DONALD C. COOK NUCLEAR PLANT UNIT NO. 2

Amendment No. 38
License No. DPR-74

AMENDMENT NO. 38 TO FACILITY OPERATING LICENSE NO. DPR-74

SAFETY EVALUATION BY THE OFFICE OF NUCLEAR REACTOR REGULATION
RELATED TO AMENDMENT NO. 38 TO FACILITY OPERATING LICENSE NO. DPR-74

Figure 3.2-1 ALLOWABLE DEVIATION FROM TARGET FLUX DIFFERENCE

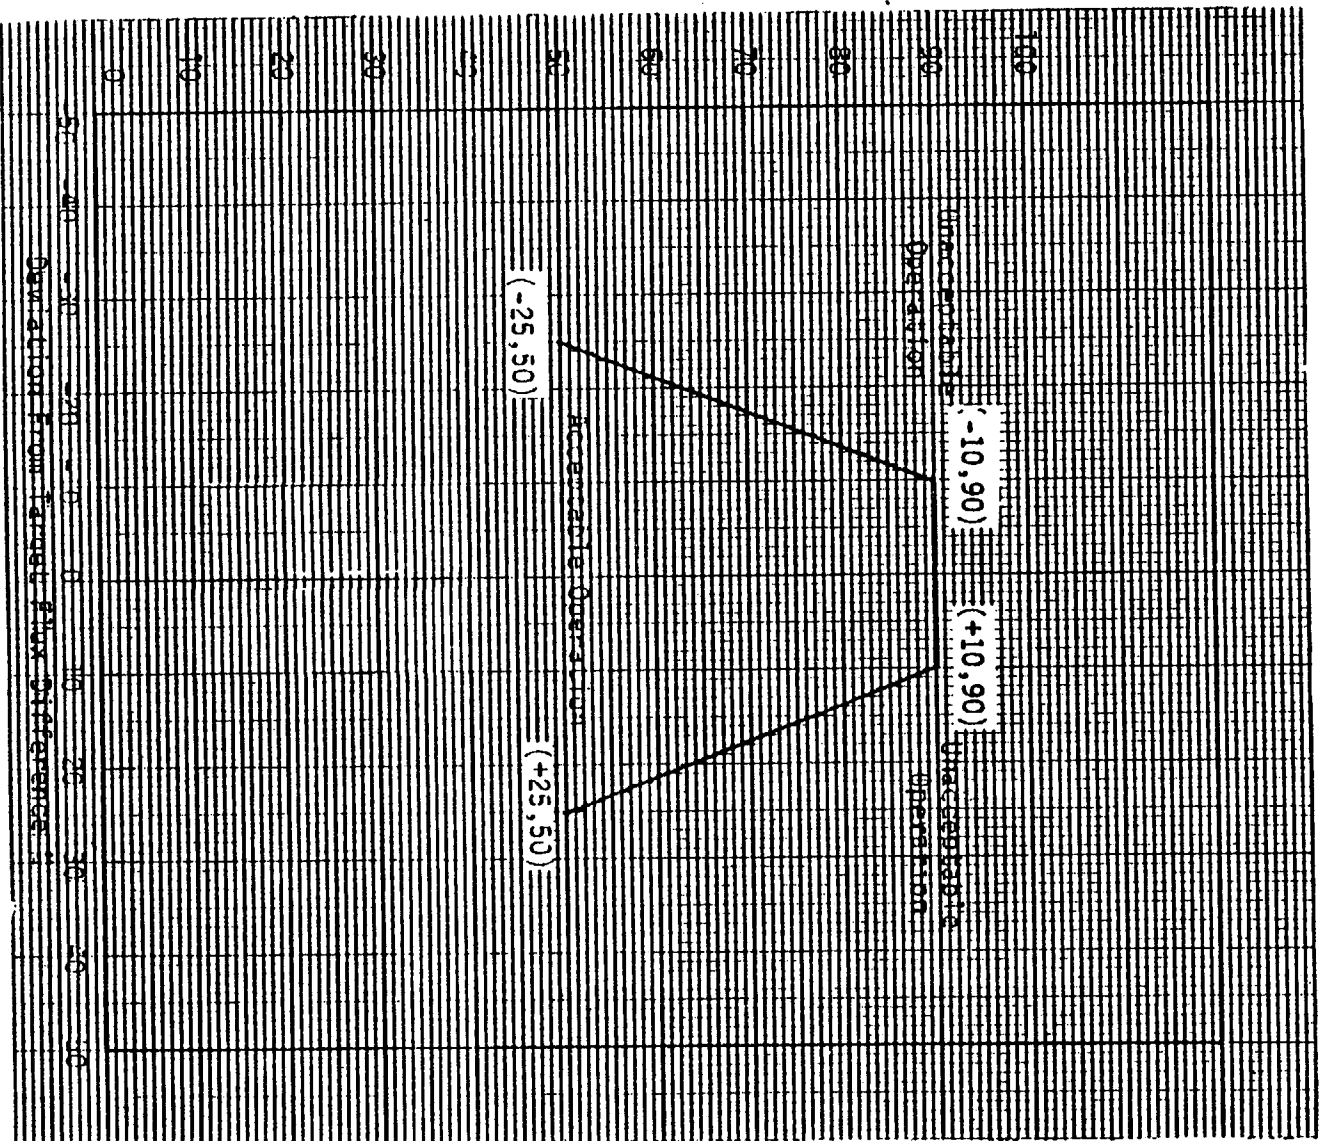
- 2) The indicated AFD is within the limits shown on Figure 3.2-1. Otherwise, reduce THERMAL POWER to less than 50% of RATED THERMAL POWER within 30 minutes and reduce the Power Range Neutron Flux-High Trip Setpoints to ≤ 55% of RATED THERMAL POWER within the next 4 hours.

- b) Surveillance testing of the Power Range Neutron Flux Channels may be performed pursuant to Specification 4.3.1.1.1 provided the indicated AFD is maintained within the limits of Figure 3.2-1. A total of 16 hours operation may be accumulated with the AFD outside of the target band during this testing without penalty deviation.

- c) Surveillance testing of the APDMS may be performed pursuant to Specification 4.3.3.7.1 provided the indicated AFD is maintained within the limits of Figure 3.2-1. A total of 6 hours of operation may be accumulated with the AFD outside of the target band during this testing without penalty deviation.

FIGURE 3.2-2 $K(Z) - \text{NORMALIZED } F_0(Z)$ AS A FUNCTION OF CORE HEIGHT

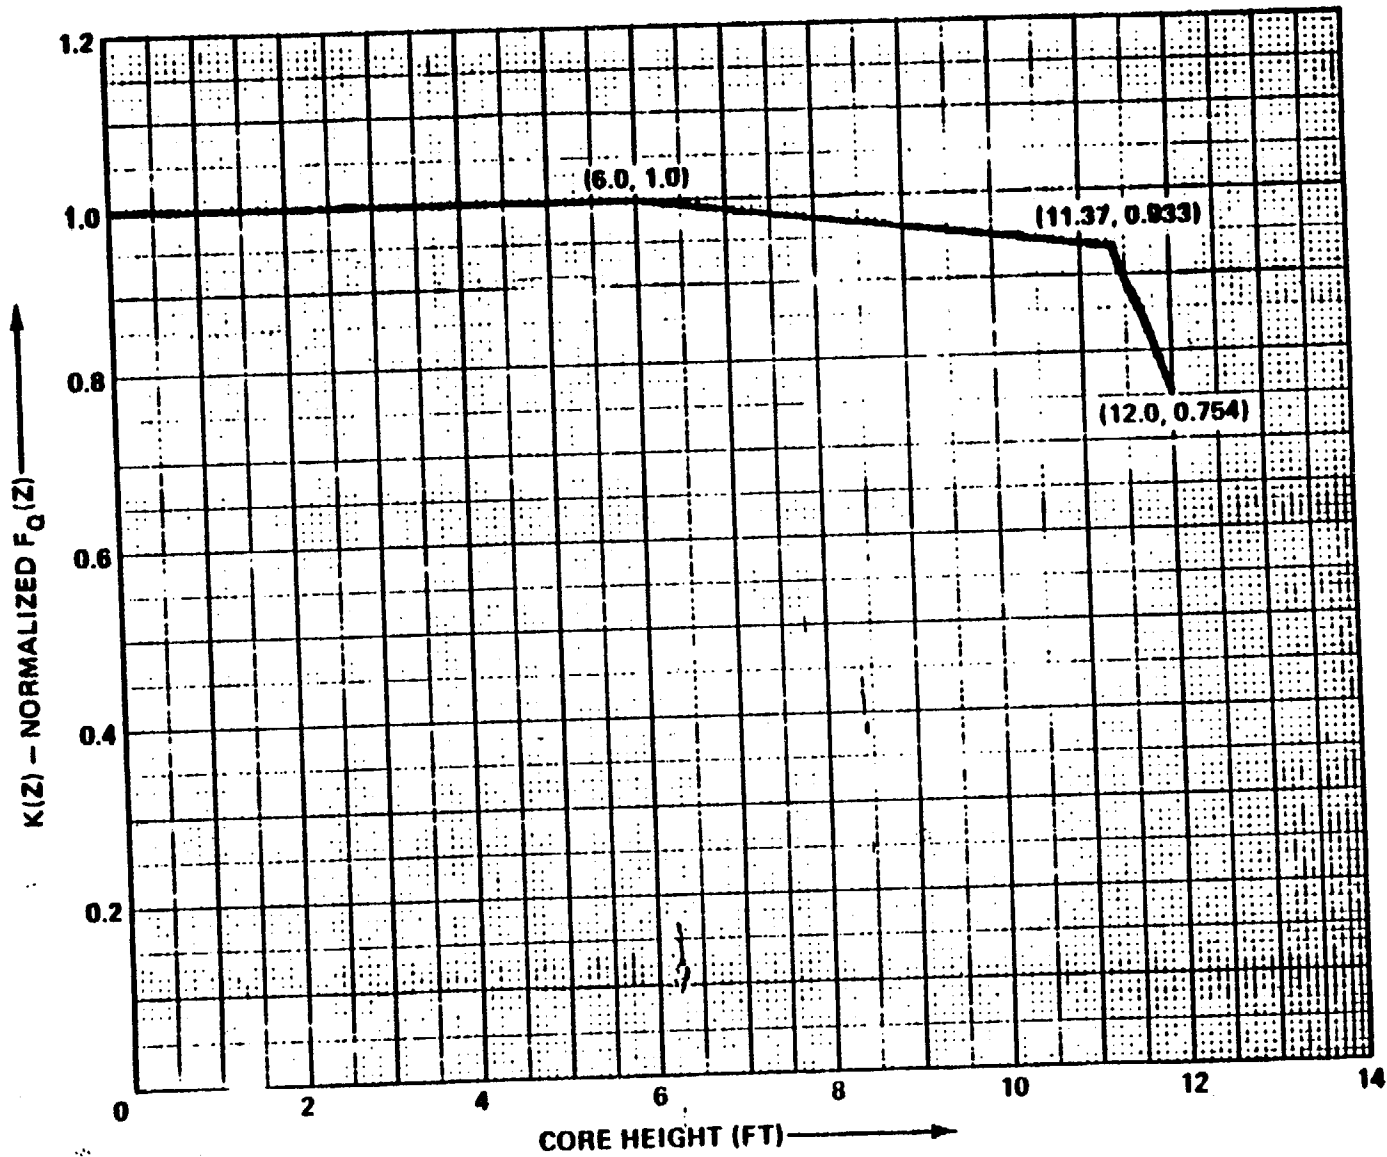
and $K(Z)$ is the function obtained from Figure 3.2-2 for a given core height location.

- $F_j(Z)$ is the normalized axial power distribution from thimble j at core elevation Z .
- P_L is the fraction of RATED THERMAL POWER.
- $K(Z)$ is the function obtained from Figure 3.2-2 for a given core height location.
- \bar{R}_j , for thimble j , is determined from at least $n=6$ in-core flux maps covering the full configuration of permissible rod patterns above 100% or APL (whichever is less) of RATED THERMAL POWER in accordance with:

Figure 3.2-3 V(Z) As A Function Of Core Height

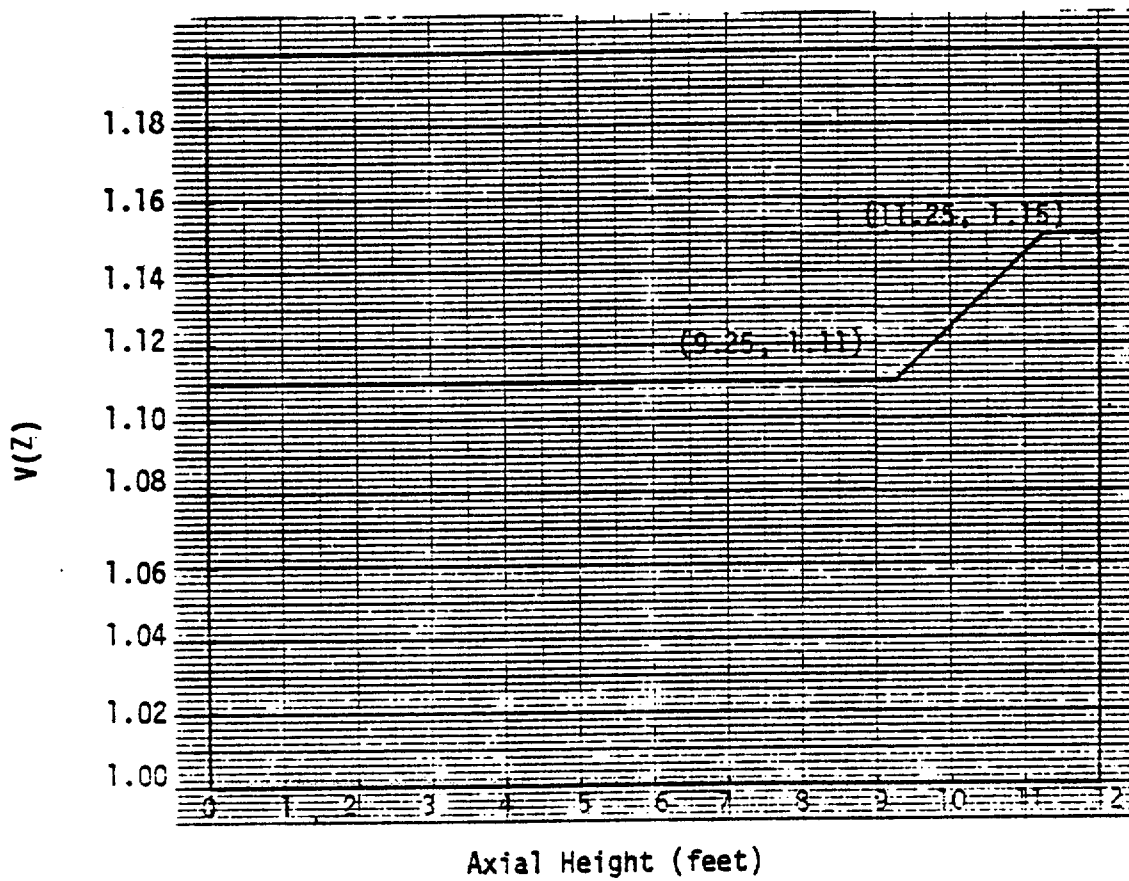
$V(Z)$ is the function defined in Figure 3.2-3, $K(Z)$ is defined in Figure 3.2-2, P is the fraction of RATED THERMAL POWER.
